American Champion Aircraft Corp.  
Rochester, WI 53167

Service Letter: 429

Date: May 29, 2007

Title: Inspection of Stereo Headphone Wiring

**Intercom Connector**

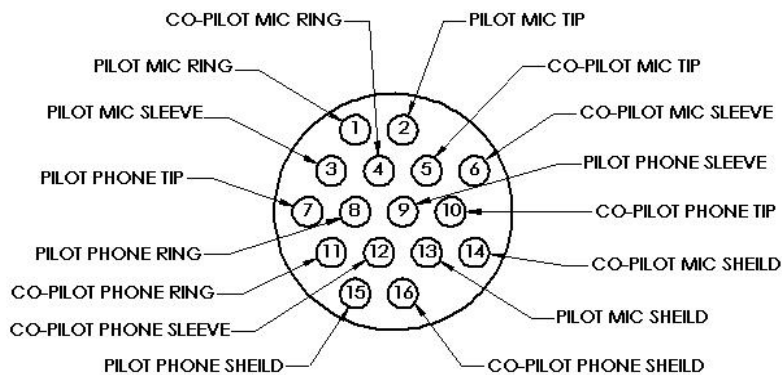
Verify correct connection of pins 7, 8, 10, and 11 to the ¼" headphone jacks using a continuity device. If necessary, swap pins 7-8 and 10-11 to match the diagram below. An AMP 305183 extractor or equivalent tool should be used to disengage the pins.
